S E R V I C E N O T E

89410A Vector Signal Analyzer**Serial Numbers:** See text for all applicable serial numbers.**Calibration failures caused by ADC shorting to heat sink****Duplicate Service Notes:** 89410A-03, 89440A-03**To Be Performed By:** Agilent-Qualified Personnel**Parts Required:**

Figure 1

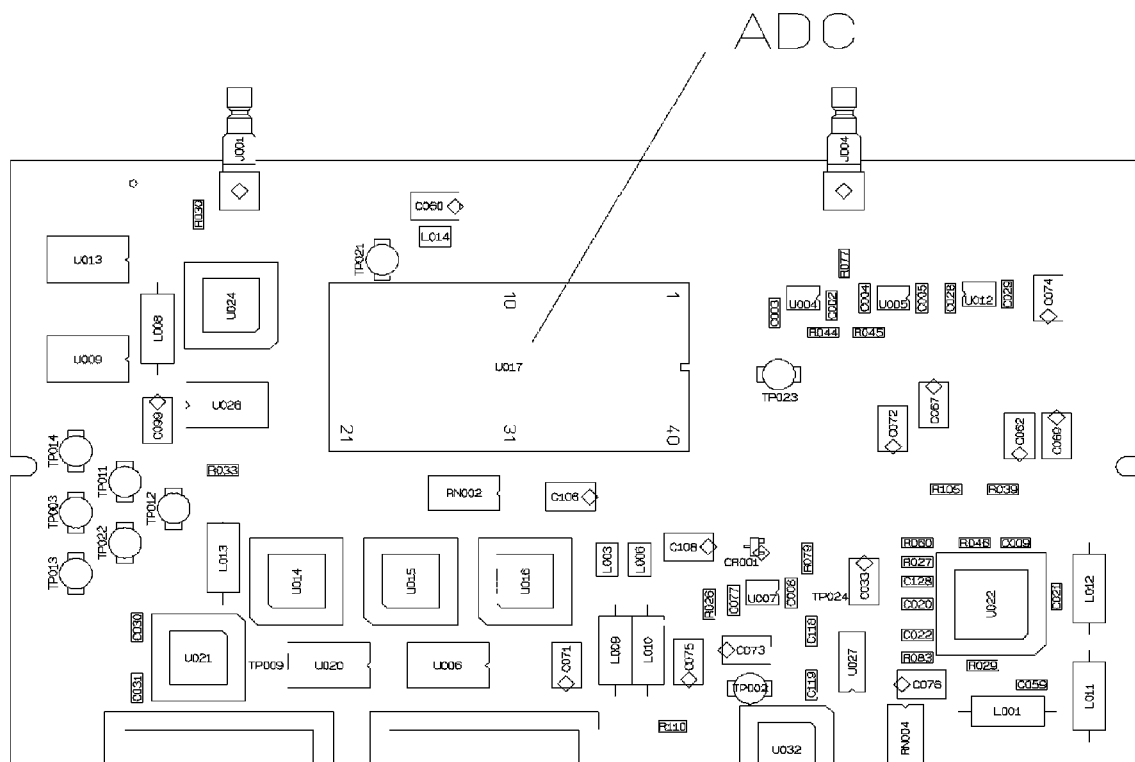
Analyzers with an IF section serial number less than 3313A00220 may have calibration failures caused by the IF section's ADC shorting to its bottom heat sink. To solve this problem, an insulator needs to be placed between the A20 U17 ADC and its bottom heat sink.

STEP 2. Install the silpad under A20 U17.

1. Remove the heat sink on top of A20 U17 using a T-8 Torx screw driver.
2. Remove A20 U17 from its socket.
3. Place the silpad on the bottom of A20 U17.
4. Install A20 U17 in its socket and replace the top heat sink.
